Date: 29 July 2026

TPB Ref.: A/NE-TKL/843

Temporary Warehouse for Storage of Metal for a Period of 3 Years and Filling of Land at Lot 554 S.A ss.2 (Part) in D.D.77, Ng Chow South Road, Ta Kwu Ling, N.T.

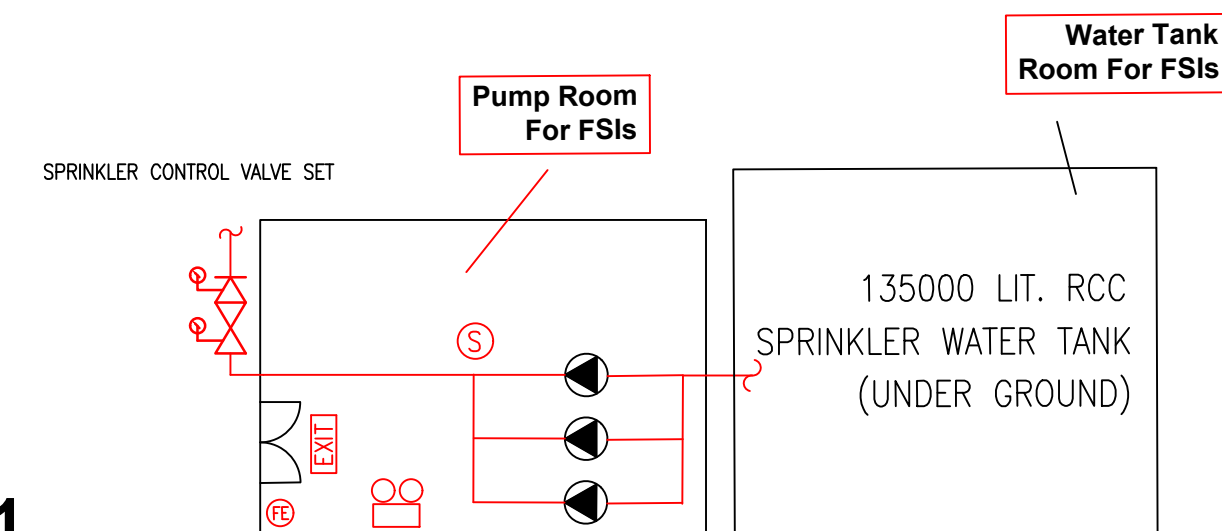
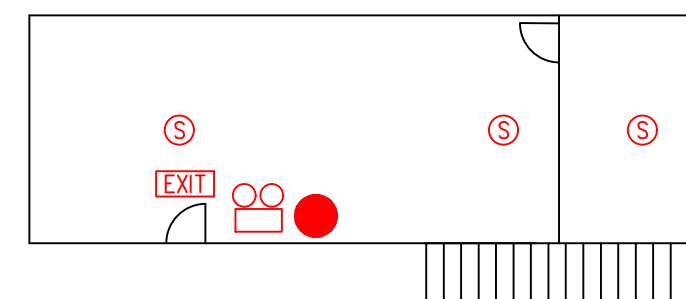
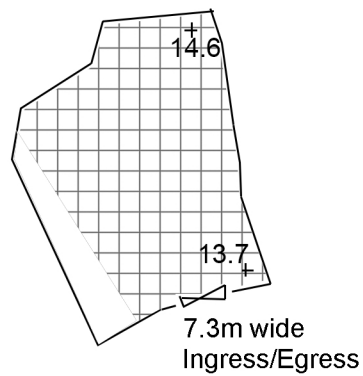
Our response to the comments of the Director of Fire Services is shown on the attached FSI plan.
